SIB 65 02 17

RECALL 17V-047: DRIVER'S FRONT AIR BAG MODULE - PRIOR PARTS REPLACEMENT

This Service Information Bulletin (Revision 7) replaces SI B65 02 17 **dated March 2023**.

GRUSB6517-04

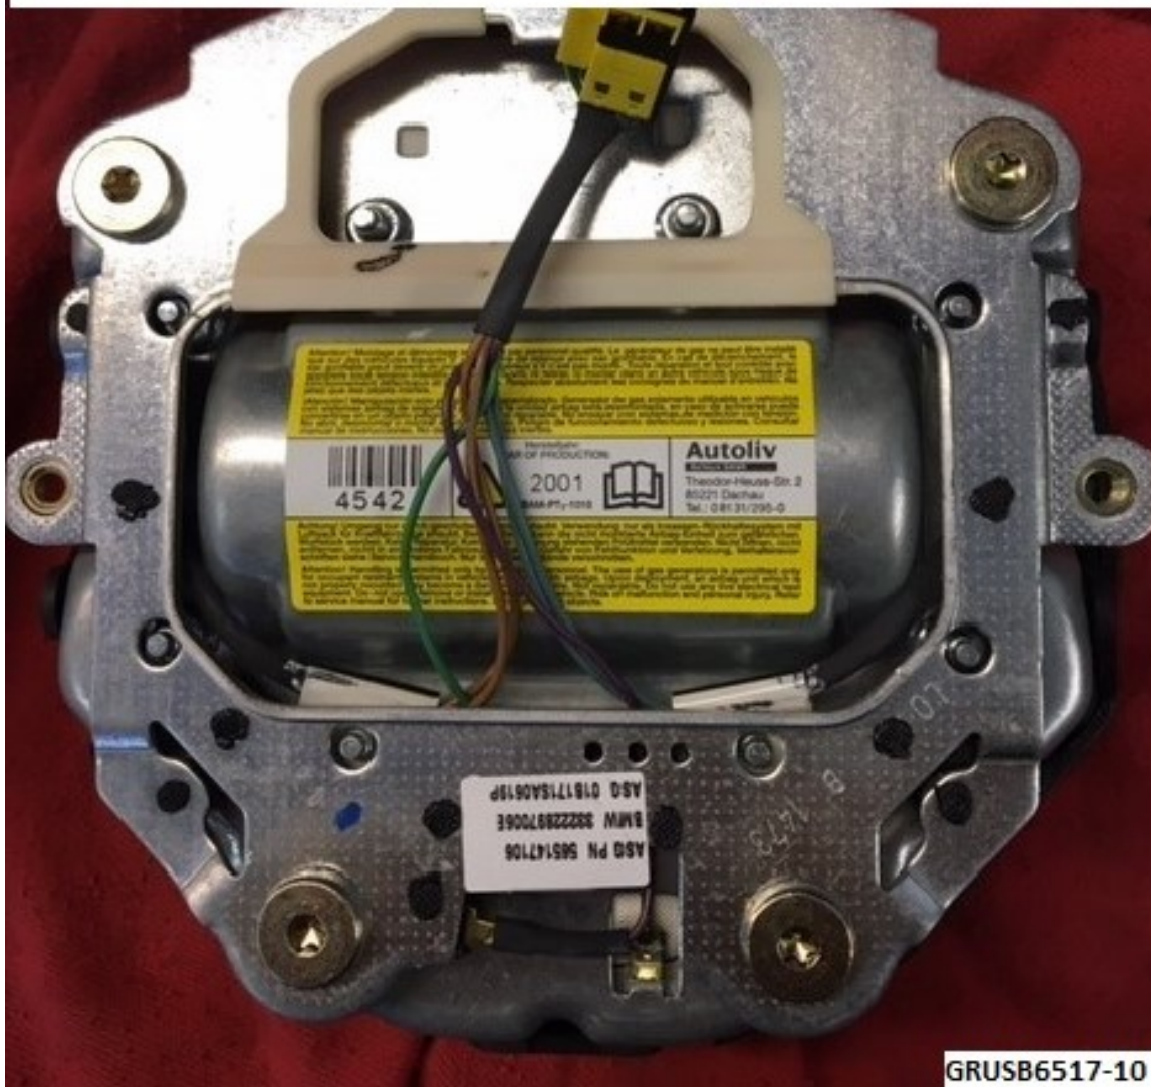
Is the label yellow with a white number sticker with printed serial number BAM XXX - 1085 (as shown below) printed below the bar code?

YES- replace air bag per the attached procedure.

NO - the driver's air bag is not affected.

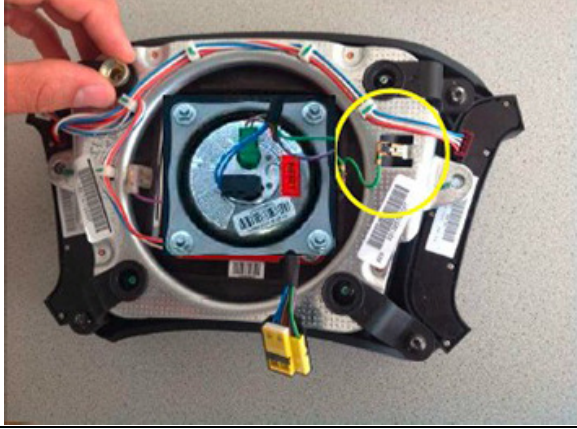
On vehicles with a basic steering wheel, the horn ring must be removed from the new part. To do so, proceed as follows:

<p>1. Remove horn ring.</p> <ul style="list-style-type: none">• Unplug the connector for the grounding cable (see the green arrow in the figure)• Remove the nuts (see the blue mark in the figure, Torx 55).
	<ul style="list-style-type: none">• Take off the horn ring, making sure that the springs remain in place.• Remove the horn contact plate.• Separate components after disassembly:<ul style="list-style-type: none">1 - Air bag module2 - Horn ring3 - Horn contact plate4 - Torx nuts
